CITY OF SAN ANTONIO

Re: Caracol Crossing

POADP # 695

CARACOL CROSSING SUBDIVISION
 PRELIMINARY OVERALL AREA DEVELOPMENT PLAN

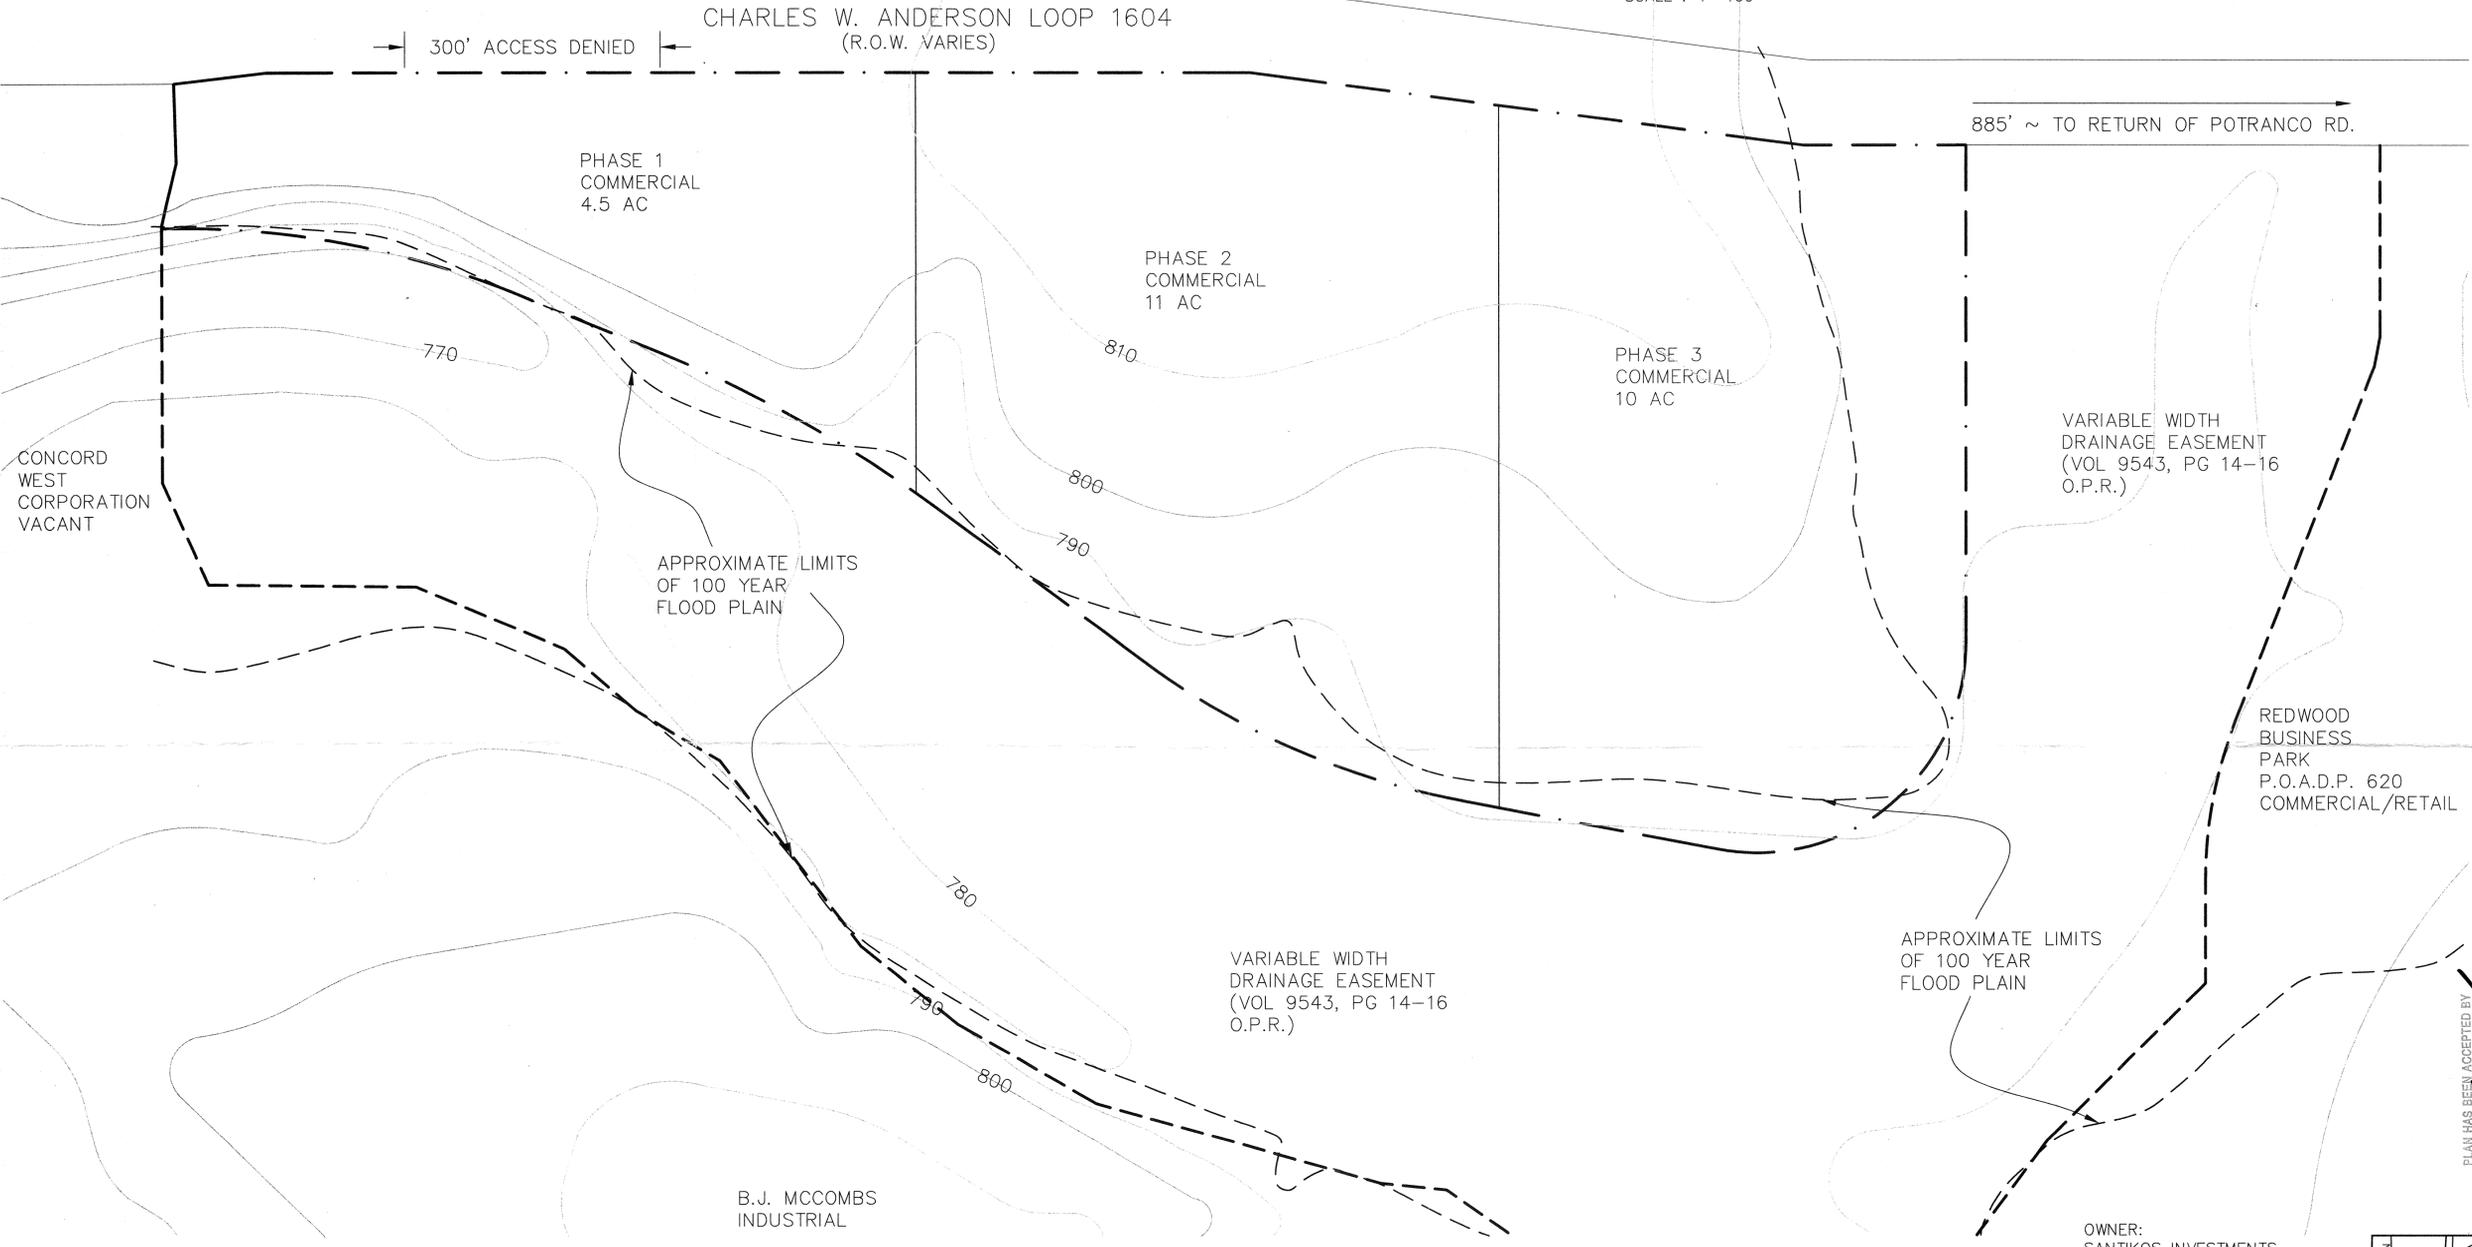
The City Staff Development Review Committee has reviewed Caracol Crossing Preliminary Overall Area Development Plan # 695. Please find enclosed a signed copy for your files. Although your plan was accepted, please note the following:

- In consideration of public safety and convenience, excessive grades by reason of topography should be avoided in street layouts and arrangements.
- Access and R.O.W. issues along state facilities will need to be resolved with the Texas Department of Transportation (TXDOT). For information about these requirements you can contact TXDOT at 615-5814.
- This development will need to comply with tree preservation ordinance #85262. For information about these requirements you can contact Building Inspections at 207-7102.
- It will be expected that you will plat all of the property depicted in your POADP, to include: floodplains, drainage areas and open space.
- I would encourage you to work closely with the school district, so that they can plan accordingly.
